DA-2022/714 37-39 Burelli Street Wollongong

Attachment 3 Design Review Panel notes

Wollongong Design Review Panel via MS Teams Meeting minutes and recommendations

Wollongong Design Review Panel
Comments in response to revised documents
4th April 2023

Extract from drawing A206 revision A

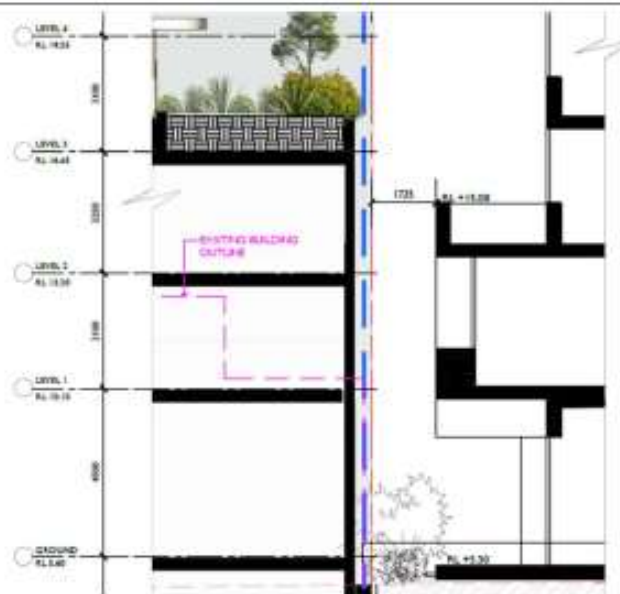
Built Form and Scale	<p><u>Interface with western neighbour</u></p> <p>The existing office building to the west is an established building form to which the proposed development should respond. The approach taken by the current proposal (and the recently approved DA) is to provide a blank wall on the western boundary. A nil setback, blank wall of this scale (in excess of 12m in height) is only acceptable in locations where a site adjoins a potential future development site. In this scenario the blank wall forms an edge to which a future building can abut to provide a continuation of built form that establishes a street wall. In locations where a development adjoins an established building form, a building interface that respects the amenity of the neighbour must be developed.</p> <p>In response to the Panels previous comments a detailed section has been provided, documenting to the proposal's relationship with its western neighbour. The detail section provided clearly demonstrates the negative impact upon the neighbouring building, eliminating outlook and significantly reducing the extent of natural light.</p>

The existing lane is a well trafficked pedestrian route that connects the public carpark to Burelli Street. The proposal locates a 12m high wall on the eastern edge of the lane, effectively blocking solar access and natural light to the lane. The height and proximity of the blank walls screening the above-ground carpark significantly degrades the quality of the lane making it a darker more oppressive environment, increasing the risk of it becoming less activated and more attractive for undesirable uses.

In response to the Panels previous comments the wall facing the lane has been annotated as a location for public art (At this stage to nature of the public art is not clear), this is a positive initiative. However, it does not address the Panels concerns in relation to natural light to the lane way. Ideally the base of the building fronting the lane should be reduced by introducing an additional level of basement carparking.

At a minimum, a collaboration with Council should seek to improve the quality of the Lane with the incorporation of public art, planting, the use of a light colour / material pallet and an upgrade of artificial lighting.
